**MARYLAND DEPARTMENT OF THE ENVIRONMENT
AIR AND RADIATION ADMINISTRATION**

**FINAL DETERMINATION CONCERNING A
PERMIT-TO-CONSTRUCT, PSD APPROVAL, AND NSR APPROVAL APPLICATION
SUBMITTED BY US WIND, INC. FOR THE CONSTRUCTION AND COMMISSIONING
OF THE MARYLAND WIND OFFSHORE PROJECT**

**MARYLAND DEPARTMENT OF THE ENVIRONMENT
AIR AND RADIATION ADMINISTRATION
RESPONSE TO COMMENTS
FOR THE
US WIND INC. - MARYLAND OFFSHORE WIND PROJECT
APPROXIMATELY 10 NAUTICAL MILES OFF THE COAST OF
WORCESTER COUNTY, MARYLAND**

Observed Wind Data – Ocean City Airport

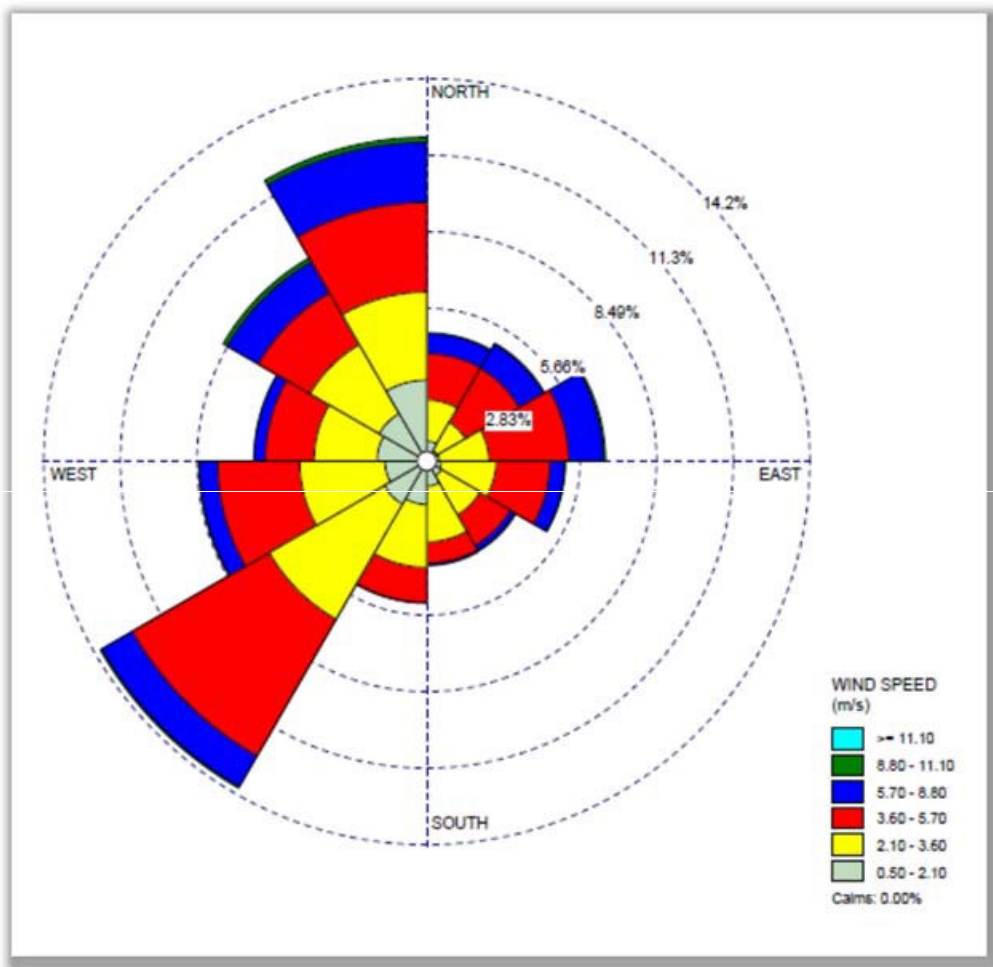
Comment 8 – Potential Wake Effects

Comments related to the potential significant impact of the wake effect from the offshore wind turbines. A commenter asked, "if a permit can be denied only based on the potential impact of this effect." There have been some concerns on how the potential wake effect may also impact or increase ozone levels.

Another commenter shared concerns related to the potential impact that wind turbines could have due to the potential increase in the ozone layer in nearby urban areas.

Wake effect" refers to the phenomenon downstream from a wind energy facility, which results from the changes in wind speed caused by the impact of turbines on each other. When wind passes through a turbine, the blades extract energy from the wind, which reduces the wind speed and changes its direction in the area immediately downstream of the turbine, creating a "wake" region characterized by reduced wind speed and turbulence.

Wind turbine wake effects would have minimal to no impact on the ozone (O₃) levels along Maryland's coastline, or near more local areas (i.e., Ocean City) and inland areas in nearby counties on the Eastern shore. The wind farm (turbines) will be operating at a distance of approximately 10.0 nautical miles (~18.5 km, 11.5 miles) offshore from the nearest shoreline.

Near Ocean City, the wind generally blows from the northwest toward the southeast or from the southwest toward the northeast. This is documented in the wind rose created using wind speed and direction collected at Ocean City Airport (taken from Appendix B – Meteorological Data Evaluation, US Wind – Maryland Offshore Wind Project Air Quality Modeling Protocol).

Since the wind near Ocean City is generally moving off-shore, and because the wake effect is felt in the same direction as the wind is blowing but after (i.e. behind) the wind turbine, the wake of the wind turbine generators would generally be moving toward the open ocean. Figure 1-2 in the permit application shows the location of the wind farm in relation to the coastline. Based on the prevailing wind, the wakes of the wind turbine generators will predominantly be on the east, or the northeast side of the wind farm on the open ocean side, not toward the coastline.
